Subject: RI Workplan, Fuel Leak Case No. R0000320, Former Paco Pumps, Inc., 9201 San Leandro Street, Oakland, CA

**SUB-SLAB VAPOR SURVEY AND REMEDIAL
INVESTIGATION WORK PLAN**

**Former PACO Pumps Site
9201 San Leandro Street, Oakland, California**

TECHNICAL RESPONSE TO ACEH COMMENTS TO 2010 REMEDIAL ACTION

**PROPOSED MONITORING WELL AND
SUB-SLAB SOIL VAPOR POINT
LOCATIONS**

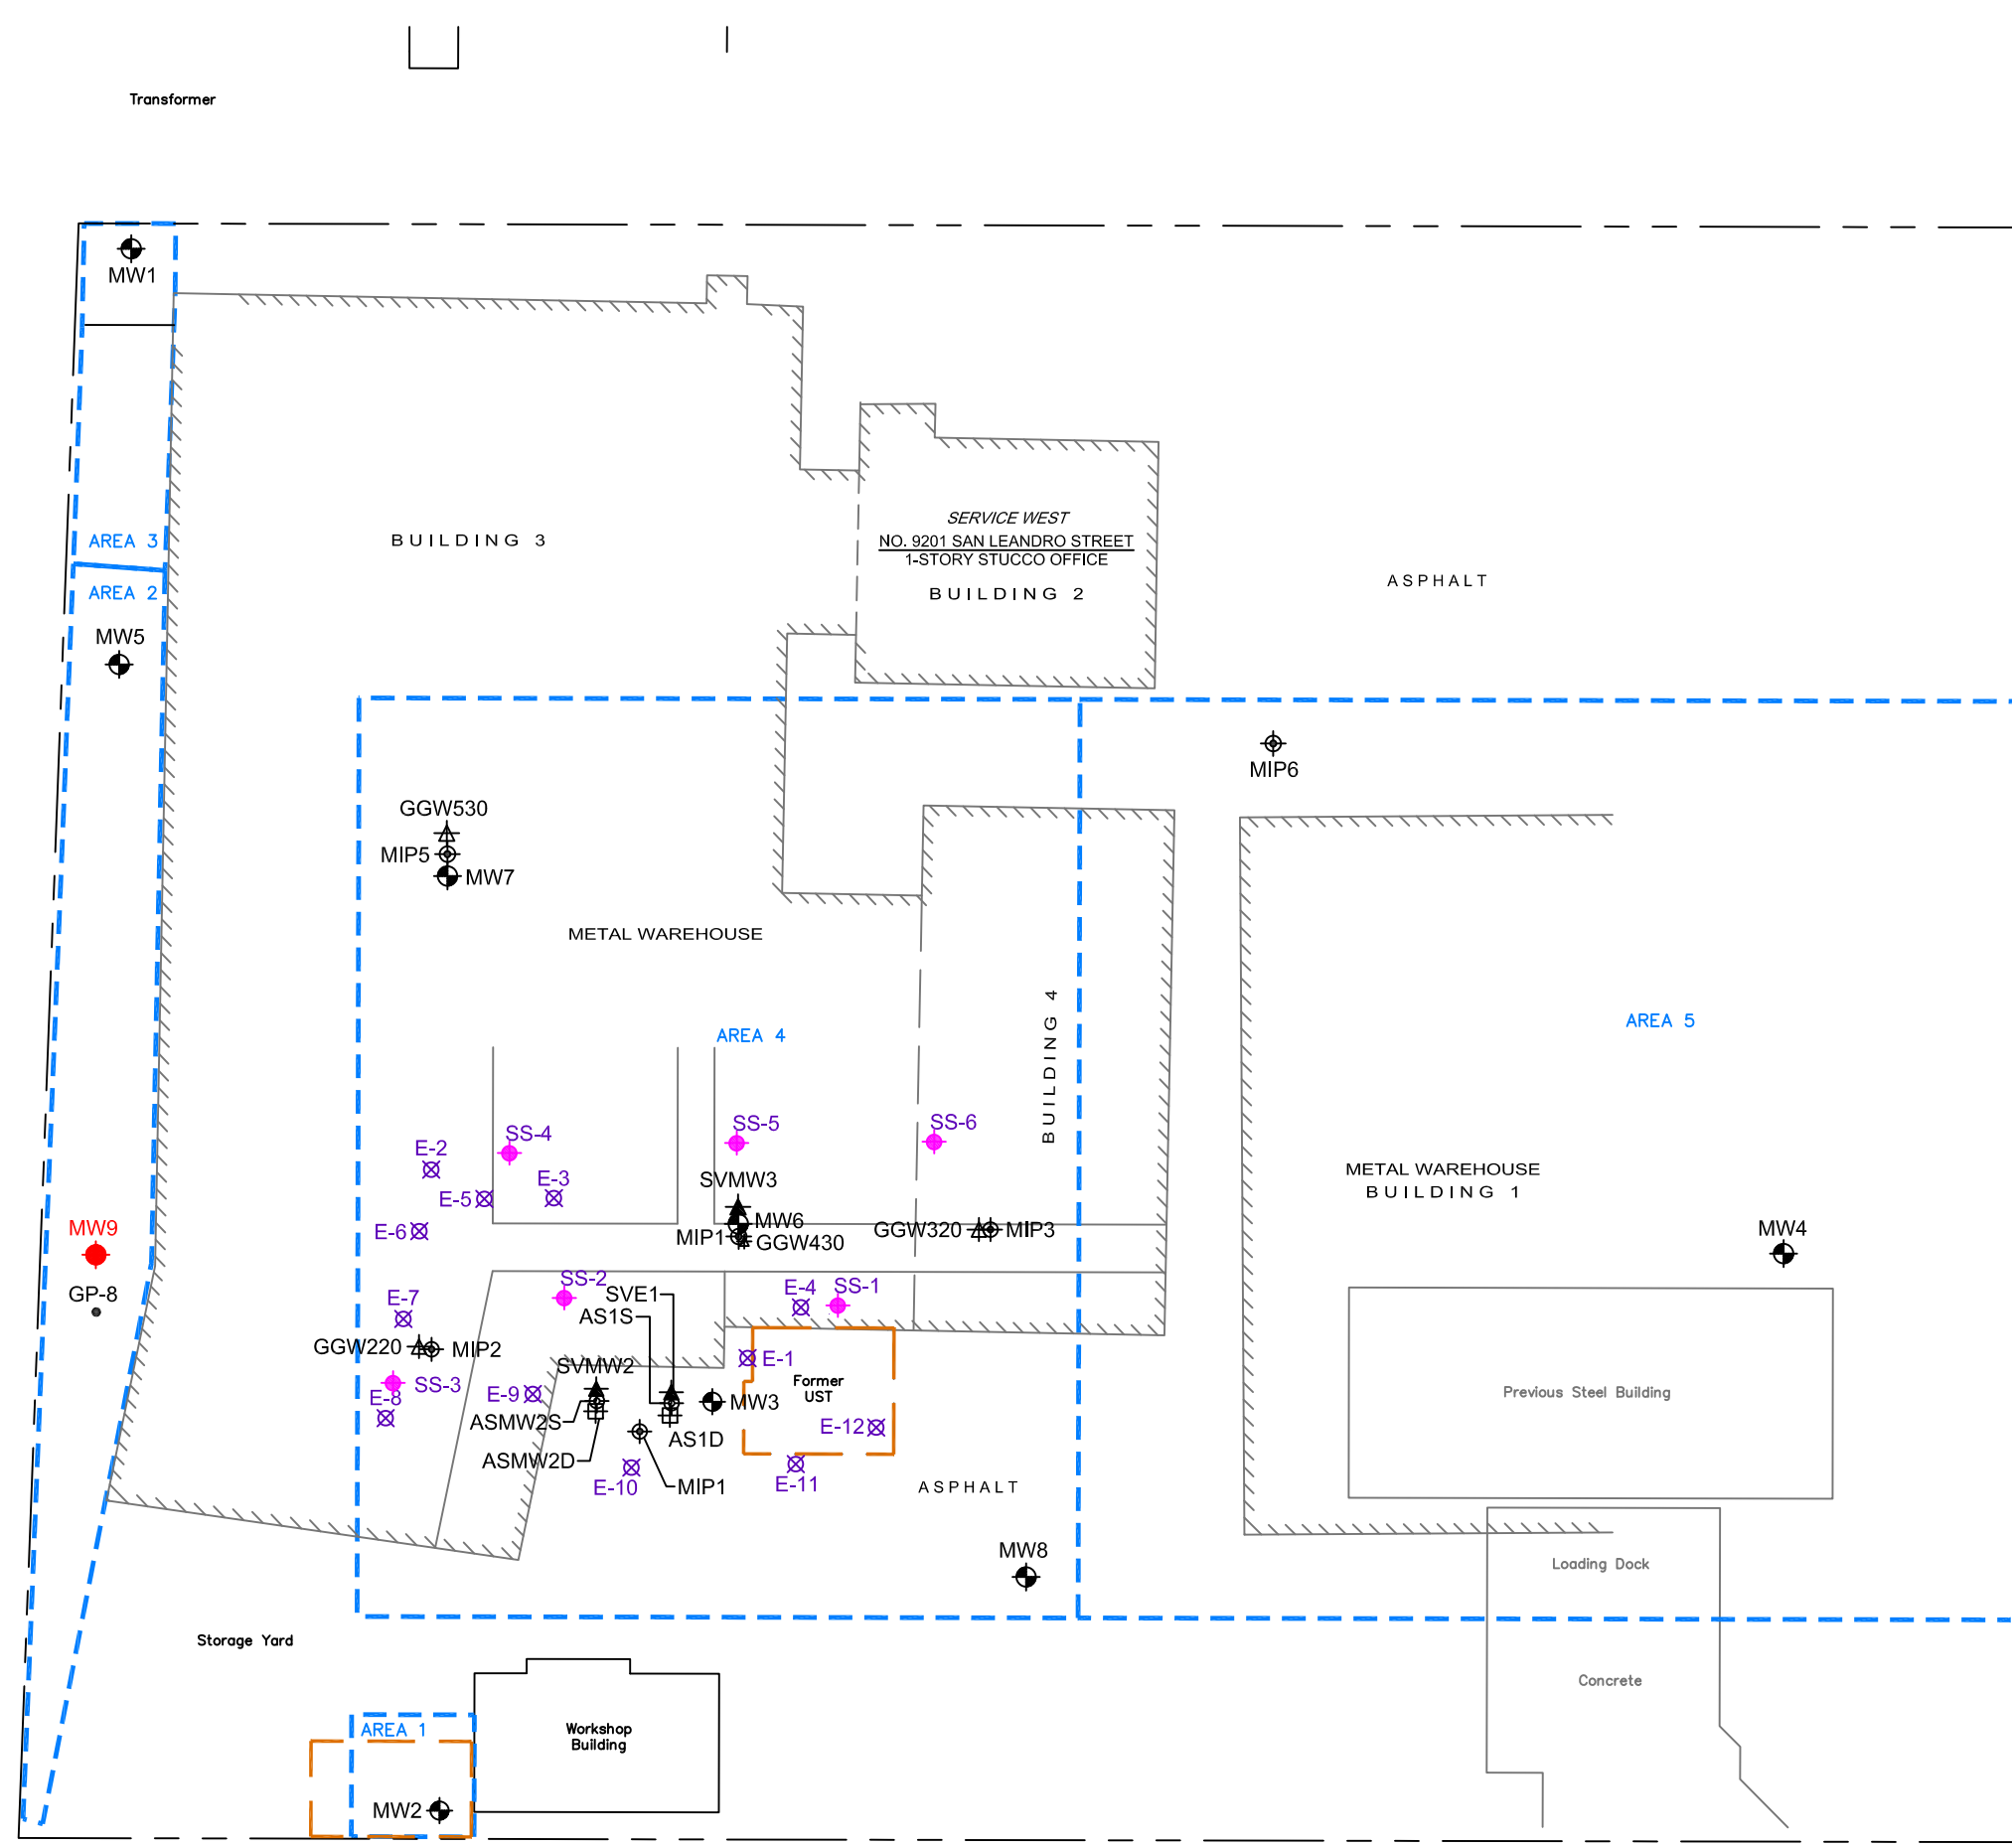
Comment: lateral extent not defined	The benzene concentrations in one soil sample and three groundwater samples from boring location GP-8 southwest of the former UST were non detectable (SGI's Q4 2010 groundwater monitoring report). A downgradient sentinel well is proposed in the alley near former location GP-8.

One groundwater monitoring well (MW-9) will be installed to additionally characterize groundwater downgradient of the Site. Figure 2 shows the location of the proposed well at the former GP-8 location. Concurrent with the sub-slab soil vapor survey, SGI will perform prefield activities that will include updating the Site-specific Health and Safety Plan (HASP), obtaining necessary permits and site access, clearing the proposed drilling and sampling location of underground utilities, and notifying ACEH (Section 4.1). Appropriate drilling applications for the new groundwater monitoring well will be prepared and submitted along with appropriate fees to the Alameda County Public Works Agency, Water Resources Section. Permit copies will be kept onsite during all field activities.
